SAMPLE DRAWINGS FOR
HOSPITALS

KILOWA.

BOH DRAWING

SUGGESTIONS FOR OPERATIONAL VIABILITY

Typical floor

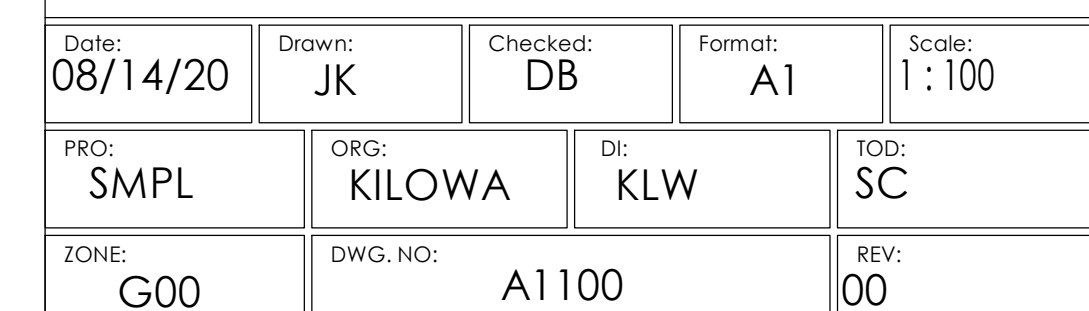
- Linen Chute location not marked in plan , it should be accessible from all maid pantry & should terminated in the laundry or Soiled linen collection area .
- Service lift lobby should be 2.4 mtr wide or min 2.0 mtr.
